Issue Number: **N172404**

Part - Location: **Ignition Key Cylinder Assembly - Column - Steering**

Complaint: **vehicle can be keyed off with knee while driving**

GMX001 Lock Module Detent in RUN

Containment Solution

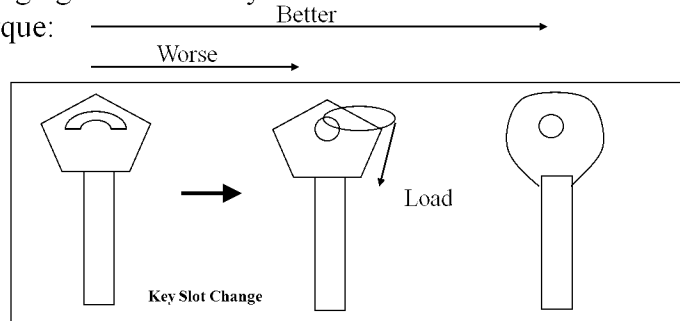
➤ Changing slot in the key in order to reduce lever arm and thus the torque:

✓ It was determined that the lever arm is still present due to fob ring. This may even cause a higher pulling load if fob ring is wedged between the slot and the sharp corner of key.

✓ Can be considered as a containment if the shape of key is changed to round corners

Partial Solution Design Concept

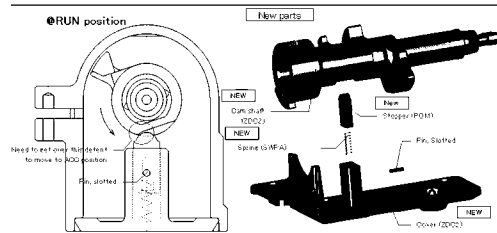
➤ Detent between lock cover and cam shaft:

- ✓ Partial solution based on engineering judgment. No experimental verification that detent is sufficient.
- ✓ If chosen, will drive changes and tuning efforts in ignition switch in order to avoid double detent feel.
- ✓ Design has to become common between Delta, Theta and Kappa
- ✓ Can be combined with the new ignition switch presently sourced for GMT191/2/3 for better detent
